Appl No 10/805,032  
Amdt dated October 31, 2006  
Reply to Office Action of May 31, 2006

**Amendments to the Drawings:**

Figure 9

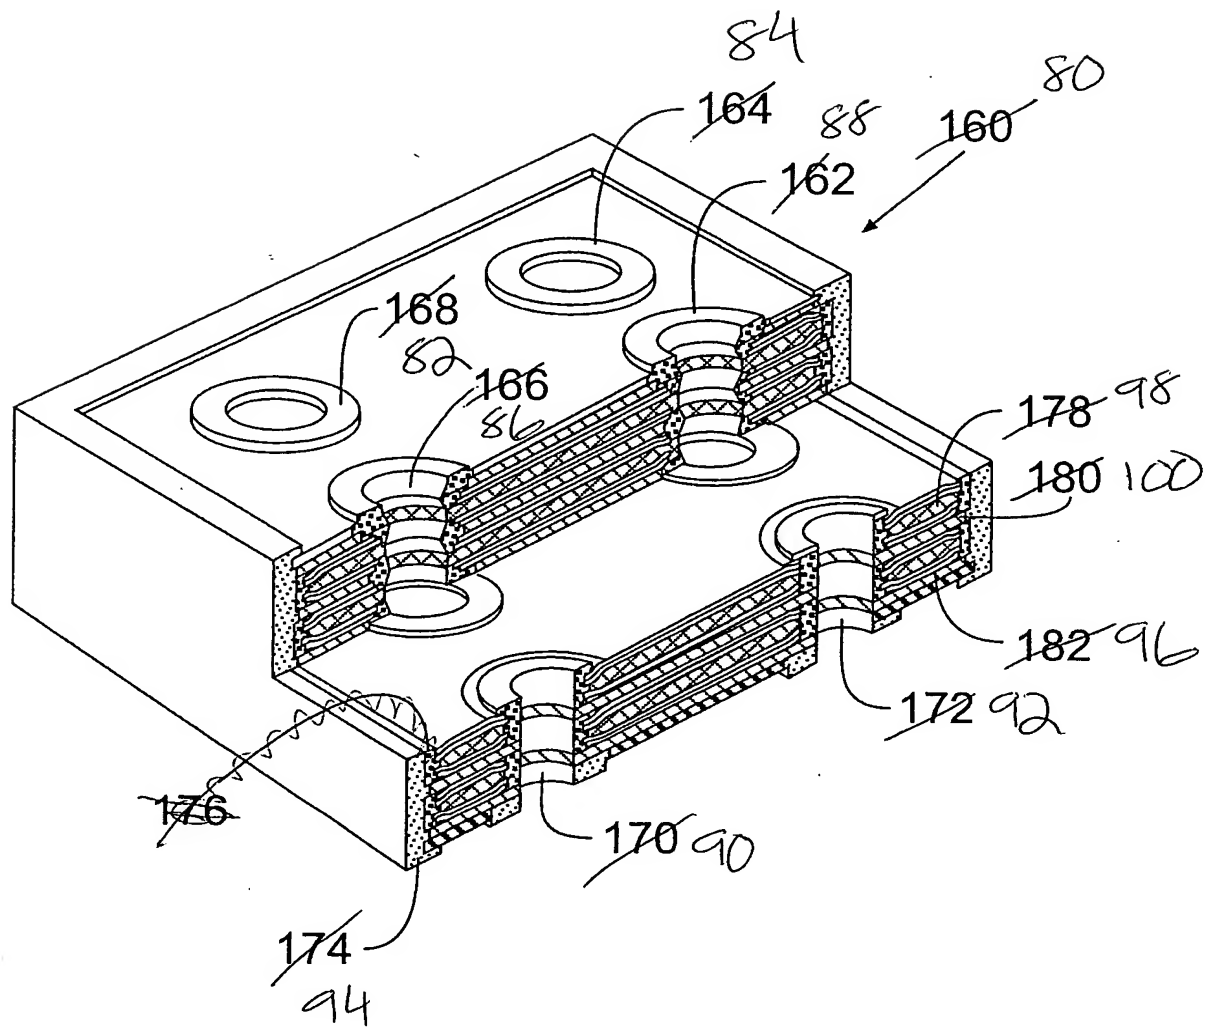
Figure. 9 is being amended to correct the reference numerals to correspond with the reference numerals referred to in the specification as originally filed. No new subject matter is being introduced. Amendments to Figure. 9 are indicated on the attached Annotated Sheet of drawing.

The attached Replacement Sheet of drawings includes changes to Figure. 9 only. The Replacement Sheet replaces original Figure. 9.
